Attachment F

Submissions

D/2017/349/A (SSD8105-Mod-1) and D/2024/854 (SSD64090972)

As an owner and resident of lots in Strata Plan 51487, known as Victoria Tower, 197 Castlereagh Street, Sydney, I object to the State Significant Modification application D/2017/349/A, and I also object to detailed SSDA -D/2024/854, both lodged on behalf of Charter Hall Holdings Pty Ltd, the Applicant, which are being assessed concurrently, in respect of 201-217 Elizabeth Street, Sydney.

Figure 55 Overshadowing Diagrams – 12 and 2pm 21 June

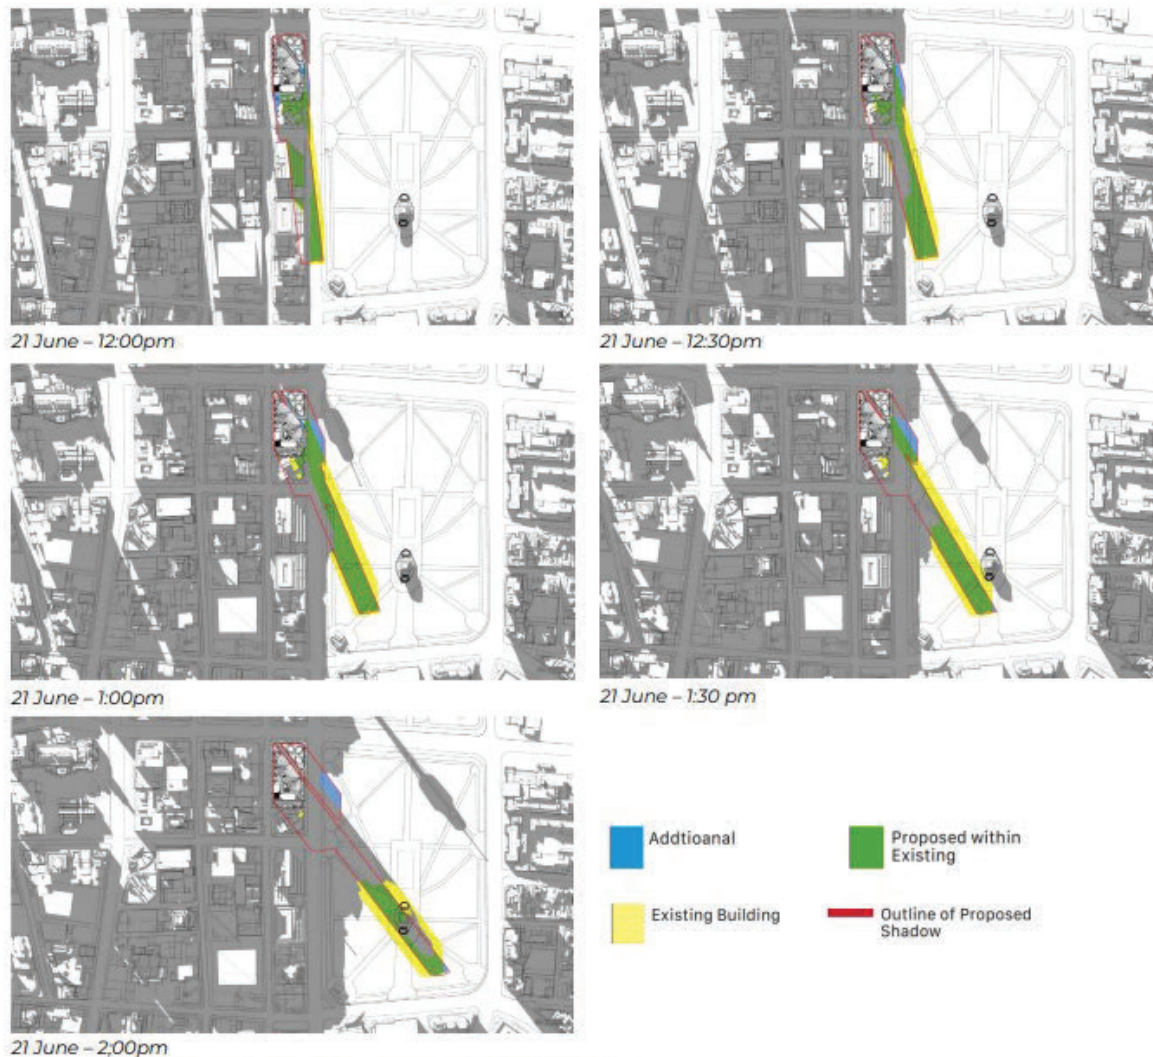
The Applicant's approach to the 50% overshadowing reduction, uses a 'cumulative' calculation, is flawed and inconsistent with the ordinary interpretation of the expression- ...“between (certain hours)”. Words should be given their ordinary and common meaning. Consequently, the requirement for at least 50% reduction in overshadowing commencing at 12:00 on the relevant day and continuing uninterrupted until 14:00 must mean that there is a continuous reduction for the whole period. The Proponent's own shadow diagrams and calculations show non-compliance at least between 12:30 and 13:00.

The Applicant's own shadow diagrams, Figure 55, which are reproduced below, clearly indicates significant overshadowing of Hyde Park in breach of the requirements of the Hyde Park sun access plane from 12 noon to 2 PM on 21 June (shown green). In addition, the diagrams also show new “Additional” overshadowing (shown blue) which breaches the prohibition.

The table of calculations, Table 21, establishes that the proposal would create overshadowing during the 12.00-2.00 period of 13086m², or 1.3086 hectares, during the busiest part of the day for users of the Park! The overshadowing at 13.00 to 13.30 is shown as 4,031m², a greater area than the entire site at 201-217 Castlereagh Street which is 3901m².
